Recommendations for ReCode Map Draft 1 and ReCode Text Draft 2

Comment Submission to ReCode Knoxville
By Knox County Democratic Party Progressive Action Committee

September 20, 2019

To illustrate the degree to which the ReCode draft map does not reflect existing development patterns, we will highlight a few of the neighborhoods we examined - Oakwood-Lincoln Park,

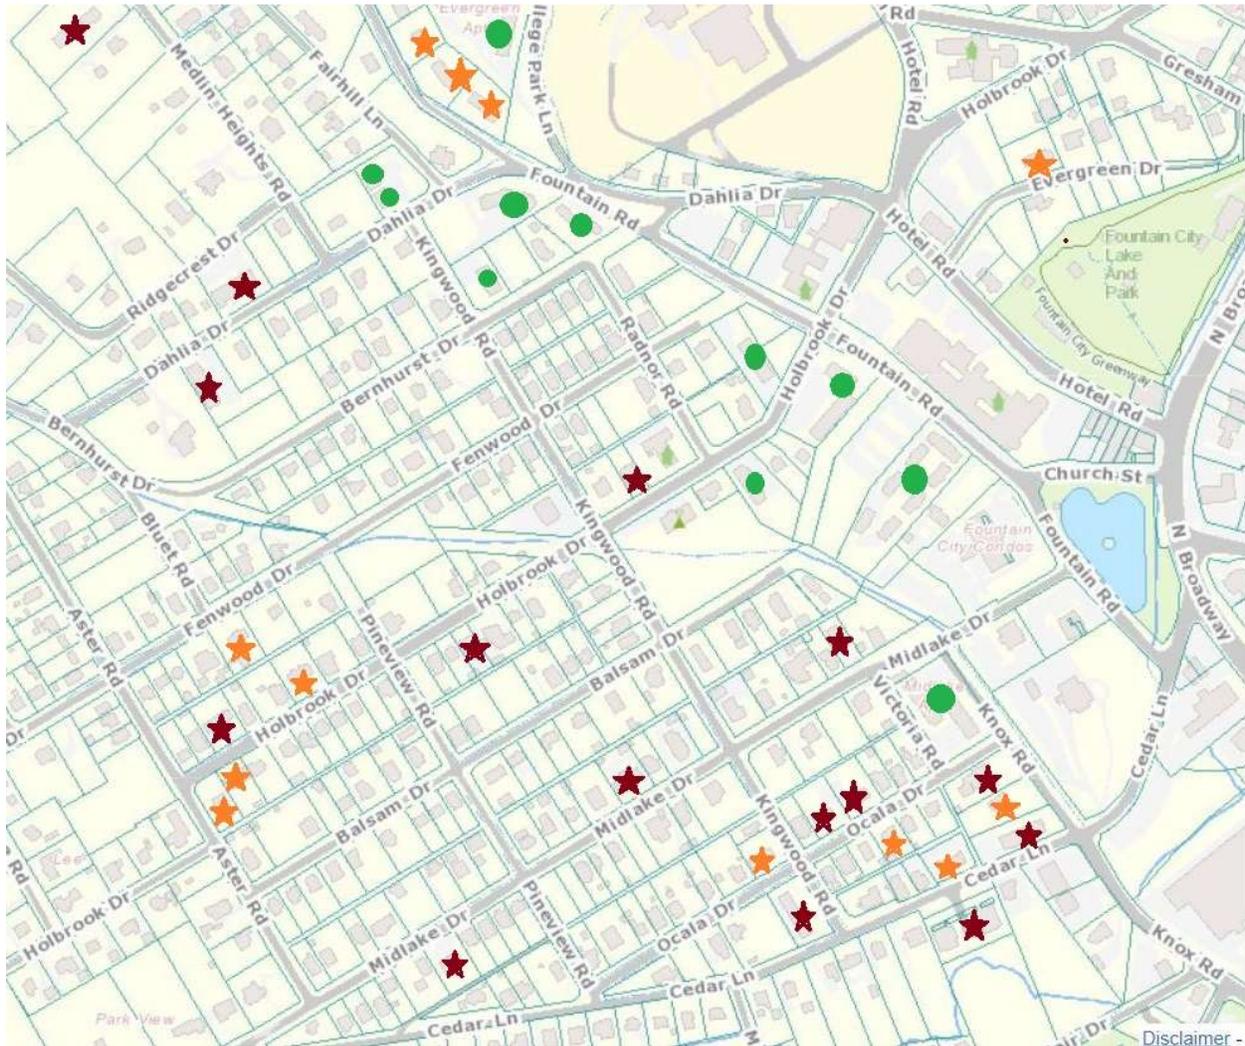
Oakwood-Lincoln Park (OLP) is a good example of a neighborhood with many blocks/parcels that have been down-zoned and options for development of affordable multifamily housing have decreased through the ReCode draft map proposal. Big chunks of the neighborhood north of E. Quincy Ave. are currently zoned R-2 with an IH-1 infill design overlay, which means that duplexes and multifamily housing are currently allowed by right. However, the newly proposed ReCode zone for much of this area is RN-2, which does not allow multifamily housing and only allows duplexes by special use.

Even in parts of OLP, such as some areas south of E. Quincy Ave., that were not down-zoned in the proposal because the original zoning was already the restrictive R-1/IH-1 zone (which allows duplexes only by special use and does not allow multifamily units), the proposed RN-2 zone still does not reflect on-the-ground development patterns when it comes to the number of existing duplexes and multifamily units.

As can be seen in the above map, this slice of OLP south of E. Quincy Ave. already has 21 existing duplexes (orange stars) and 7 existing multifamily housing units (red stars) that would not be allowed to be built by right under the proposed RN-2 ReCode zone. In proposing to zone this area RN-2, MPC has not followed its pledge to make sure the new zoning district “adequately represents on-the-ground development patterns”.

PAC recommends that OLP be zoned RN-4 to more accurately reflect the existing development pattern of the neighborhood and allow for future development of more affordable multifamily housing options by right. Appropriate, not overly expensive or burdensome, design standards as well as tear-down restrictions for historic structures can be utilized to ensure future development is in character with the existing neighborhood and that significant portions of this historic neighborhood are not replaced with all new development.
